This letter is response to Application No PL/2023/10664.

off road parking at 88 Castle Rd.

Below is the plan of ~~the~~ A345 road

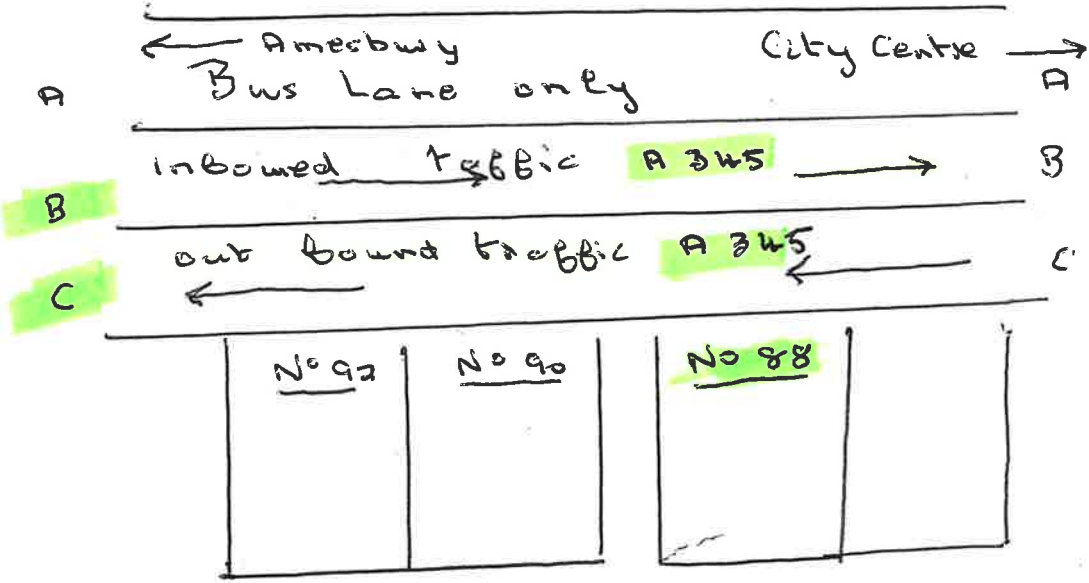
Road B inward Bound

If they wish to park their vehicle when travelling inbound they will have to obstruct traffic using road C outward bound

If they where using road C they would still have to obstruct the outward traffic then back into their bay.

If they drove into their purpose bay it is an offence if reverse out onto a live lane.

The A 345 is a very busy road at all times a day.
